CITY PROJECT NO. 14079
CONTRACT NO. 8709

ADDENDUM #1- 5/17/2024
REVISED THE
FOLLOWING:
TITLE SHEET
GI2-GI5, PD1-PD2, PD5-
PD6, P1-P2, P5-P6, U2-U6
REMOVED THE
FOLLOWING:
GI2 AND GI6

REVISION #1- 8/15/2024
REVISED THE
FOLLOWING:
EC4, EC6, GI1, GI3-GI5,
PD2-PD6, P2-P6, U4-U5,
W1, X4-X5, X7, X9, X12

REVISION 2: 3/21/25
REVISED THE
FOLLOWING:
P2, P3, PD2, PD3, U1, U2,
U3, U7

14079
EC-6

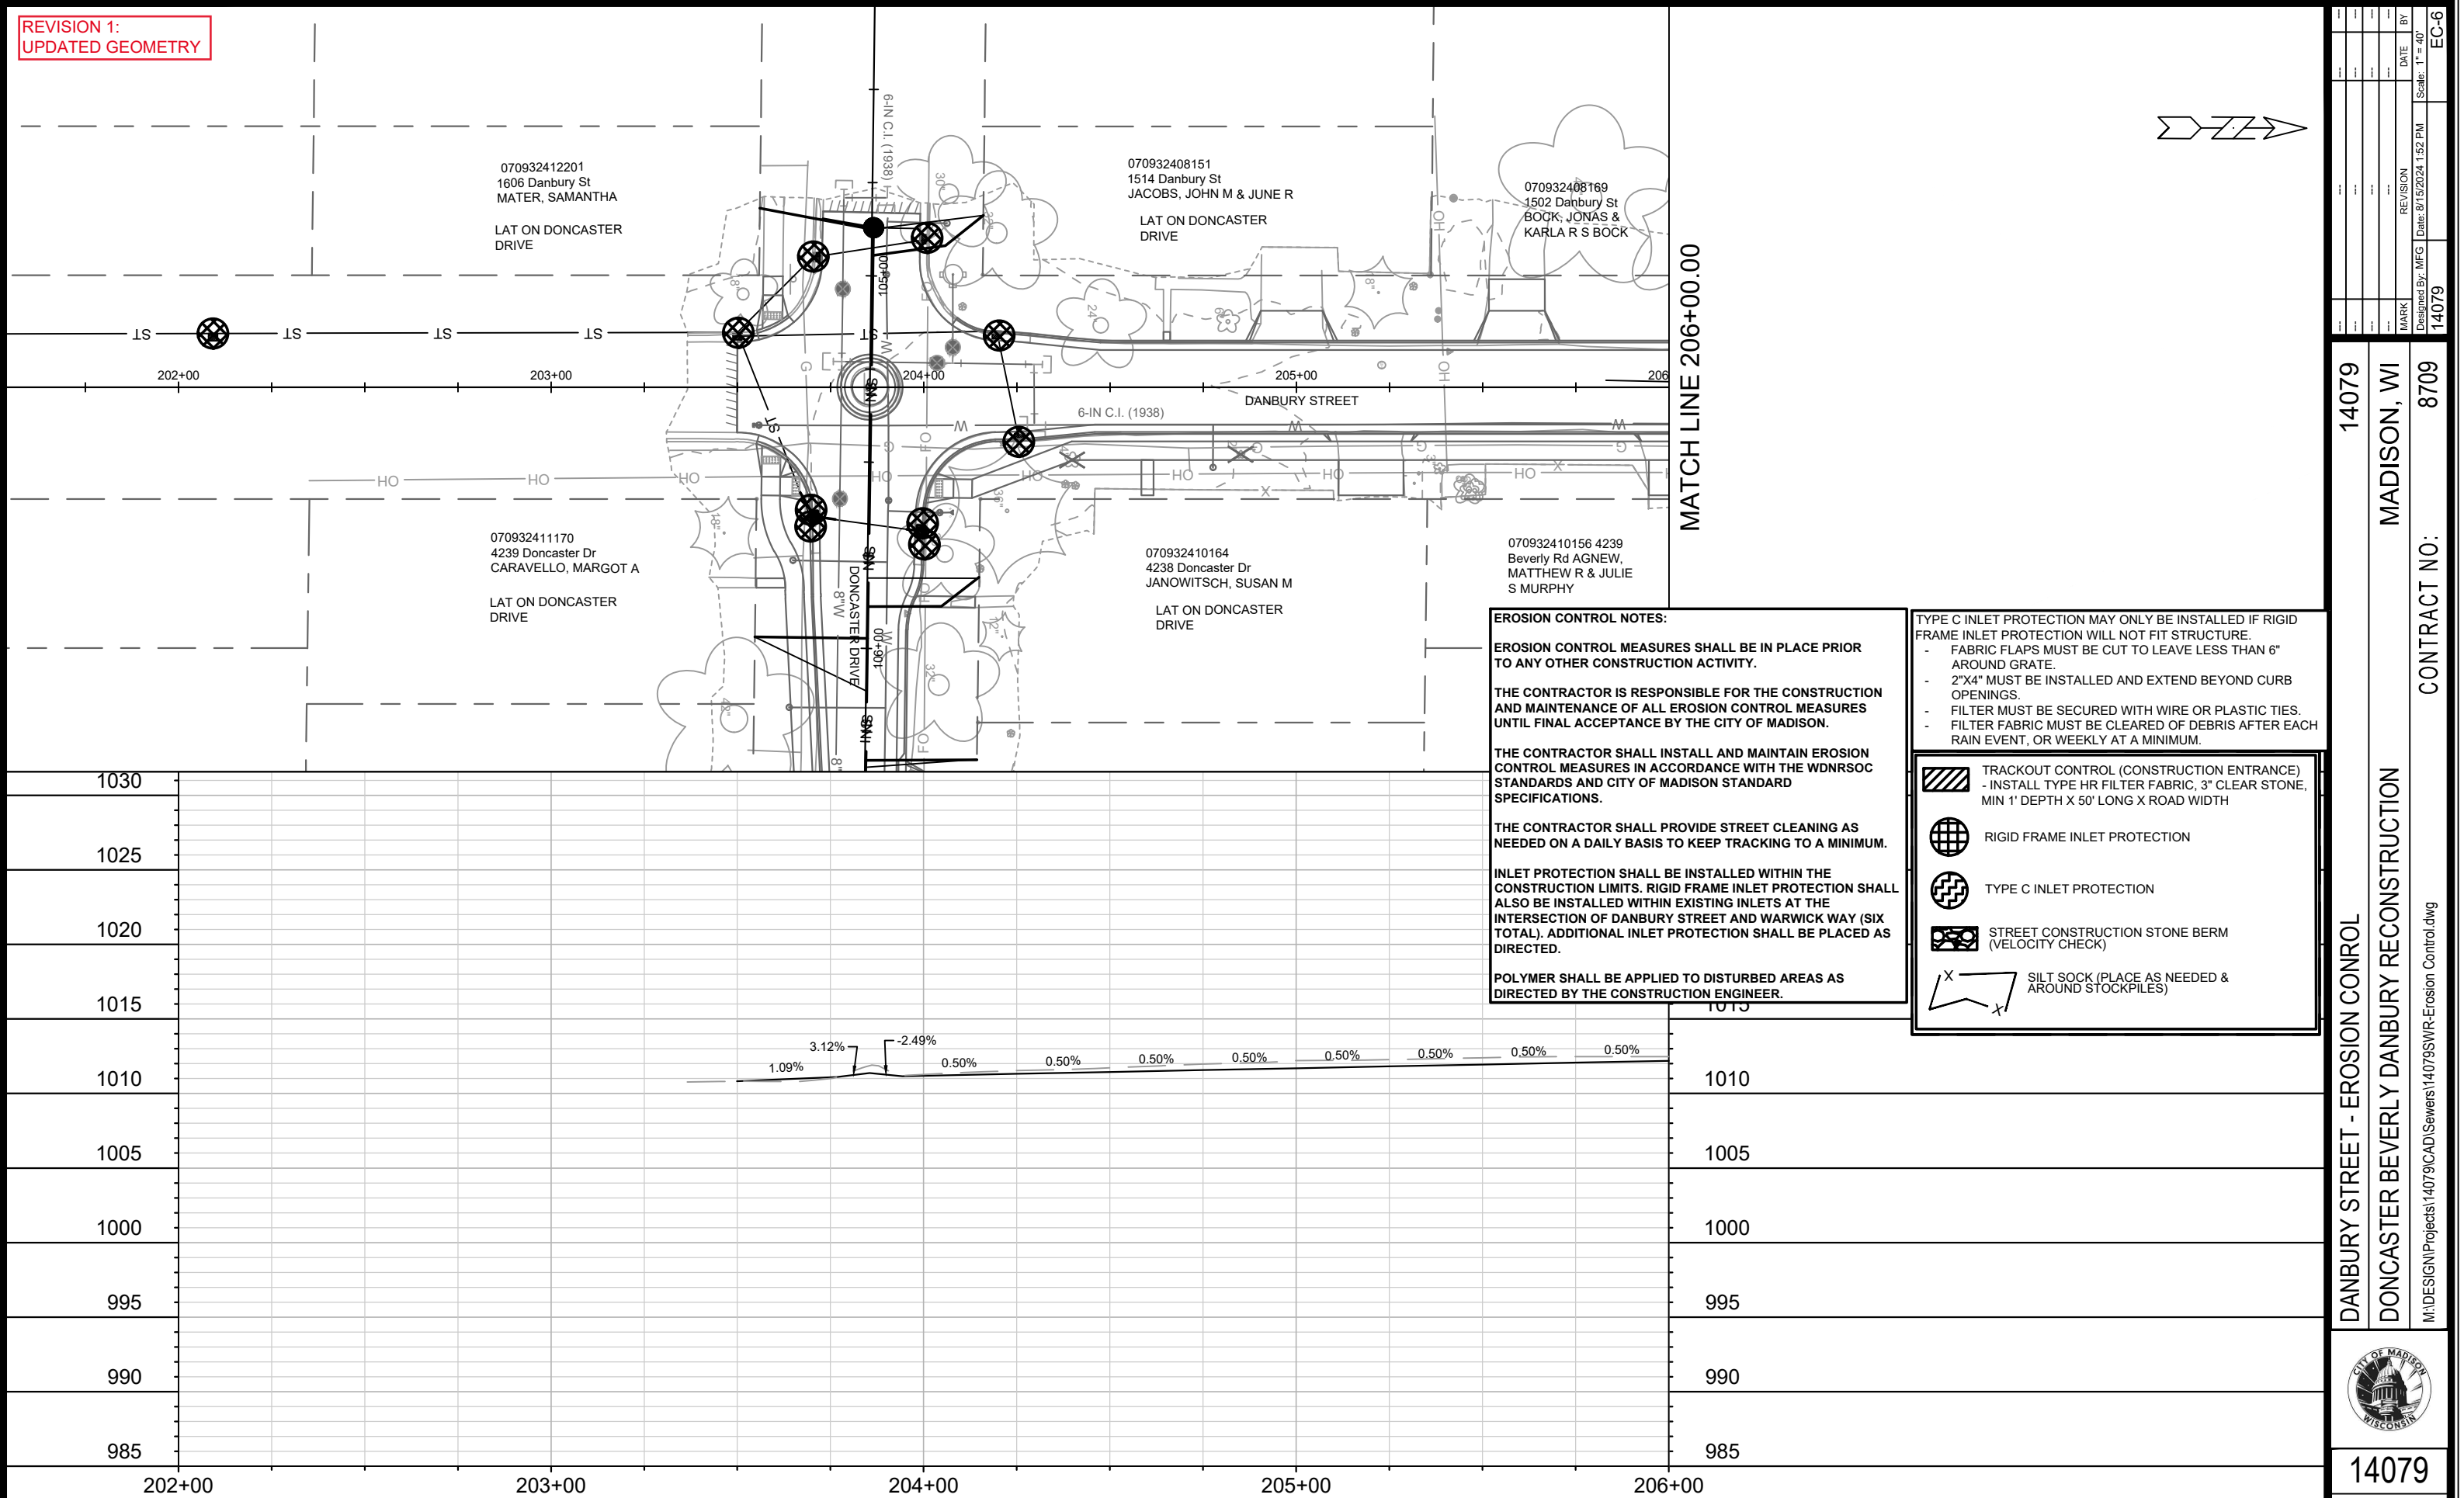
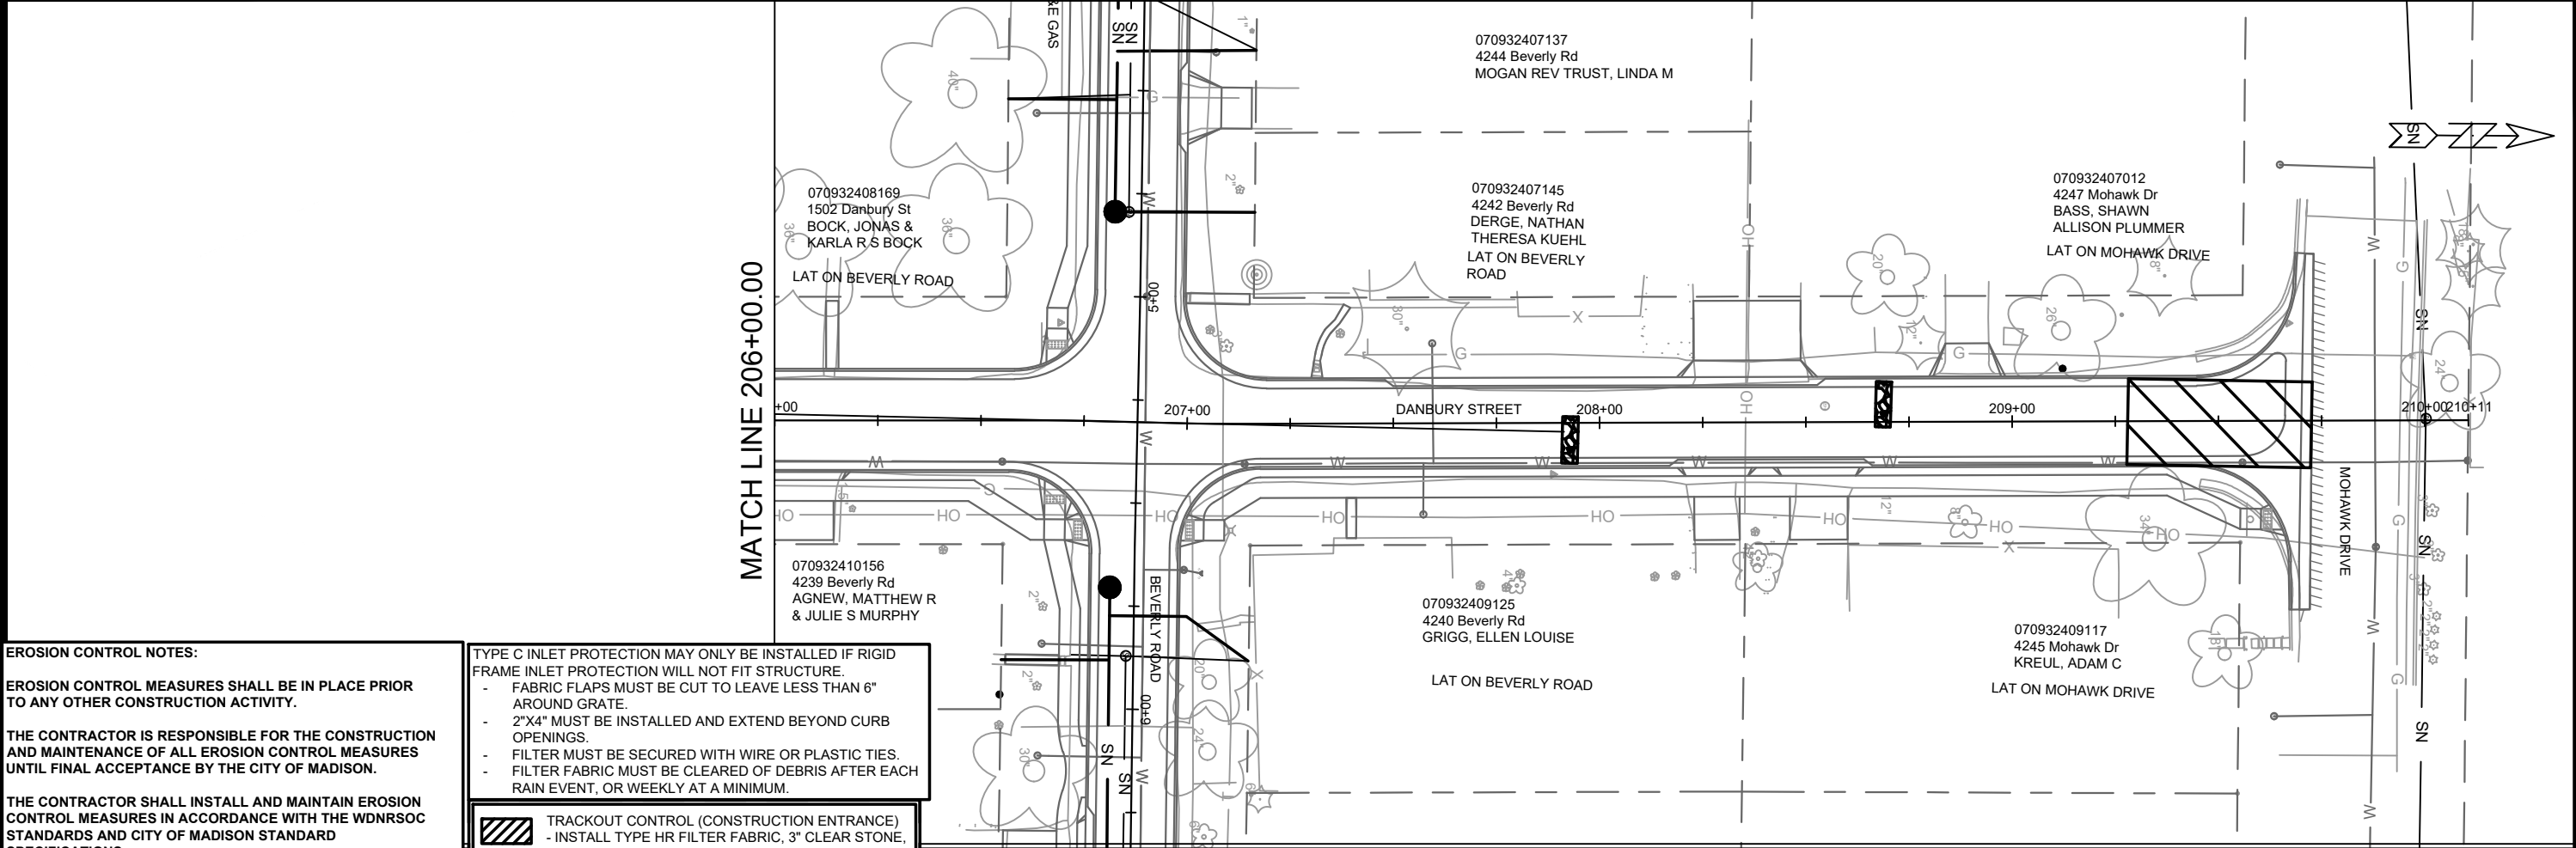
REVISION 1: UPDATED GEOMETRY

GI-3

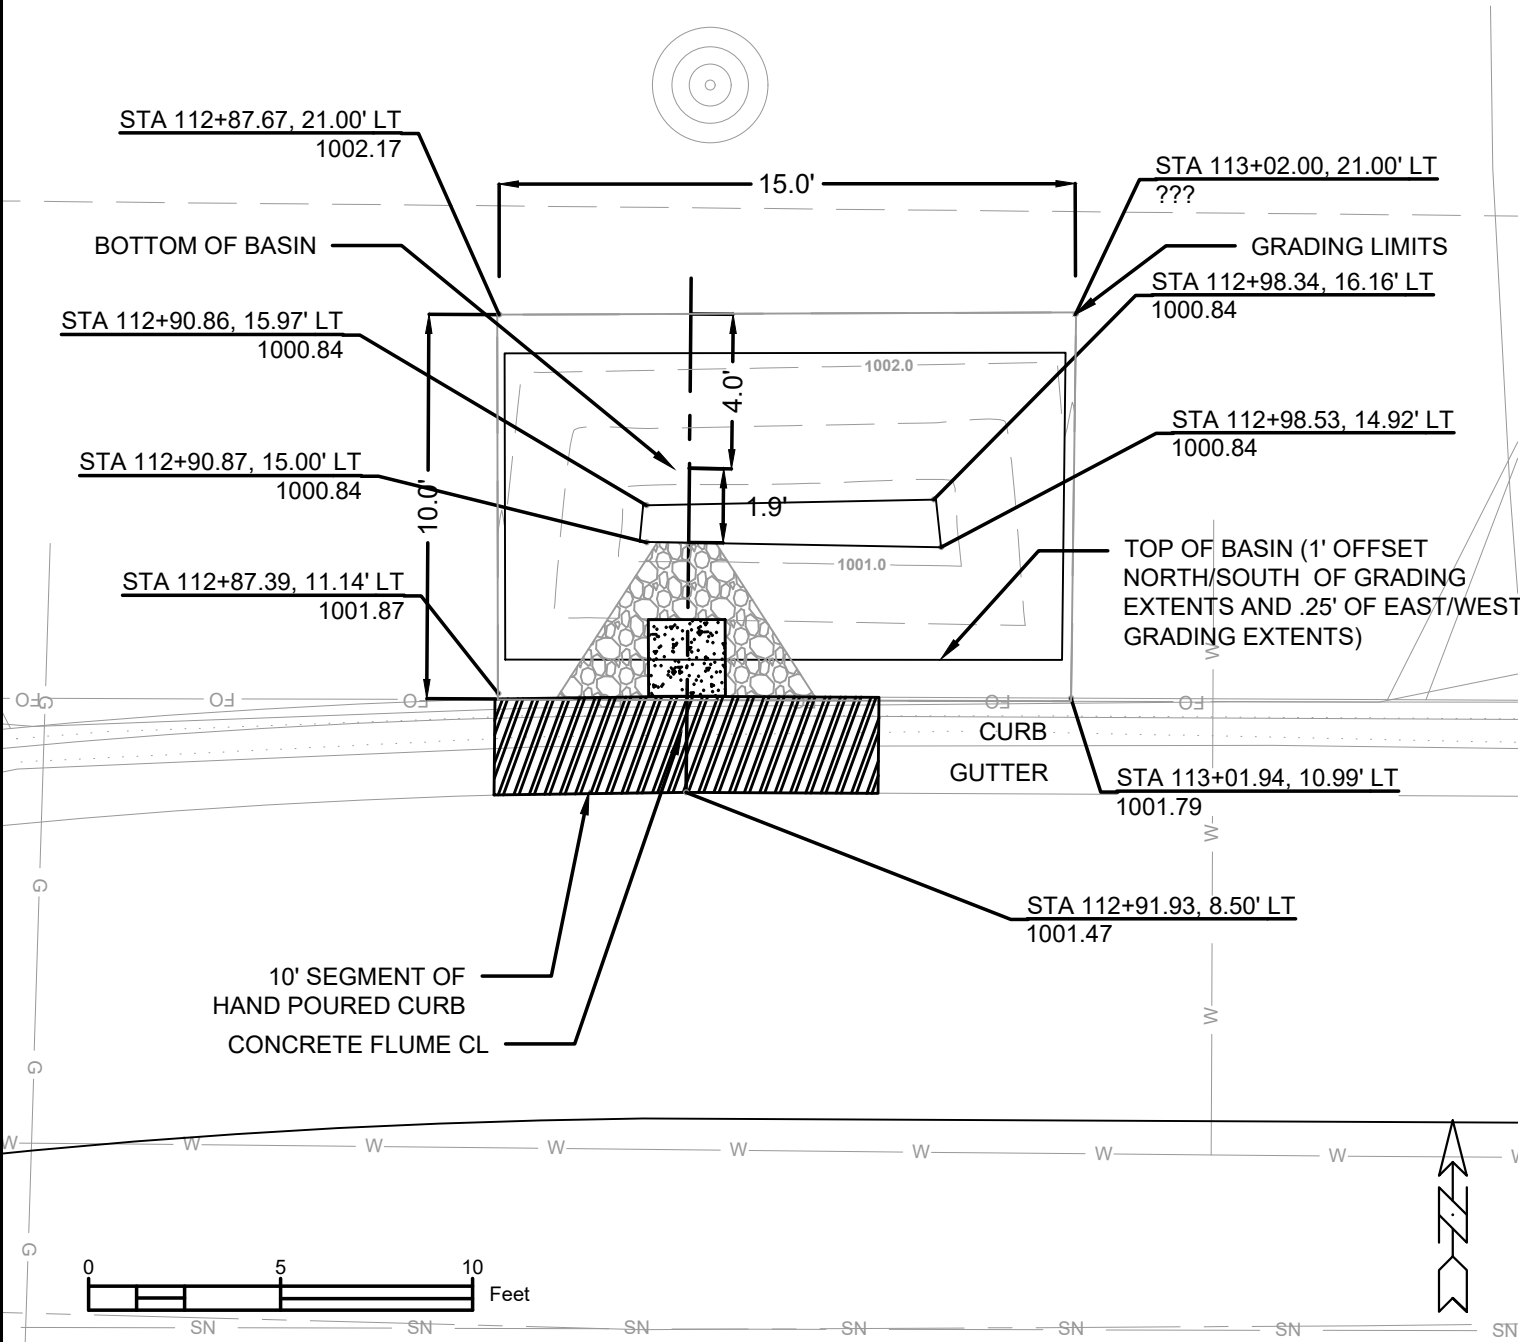
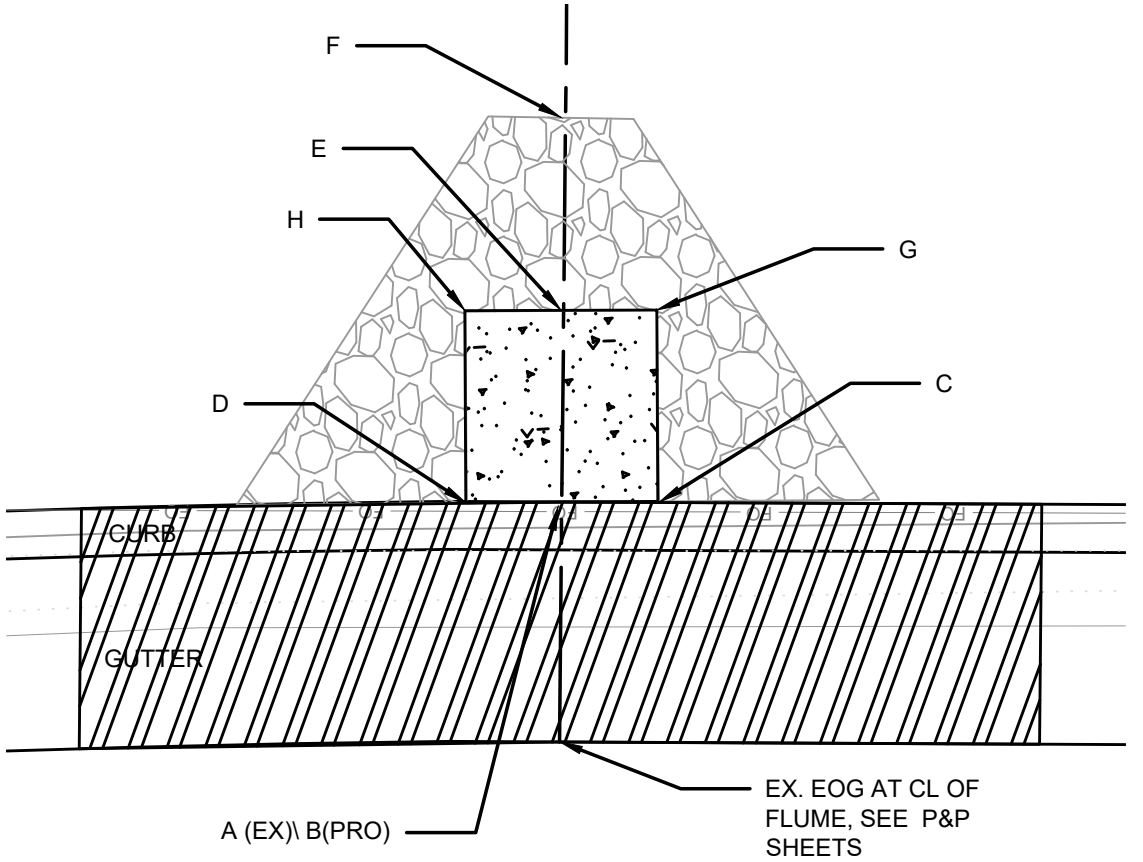
REVISION 1:
UPDATED TO
NEAREST ALIGNMENT
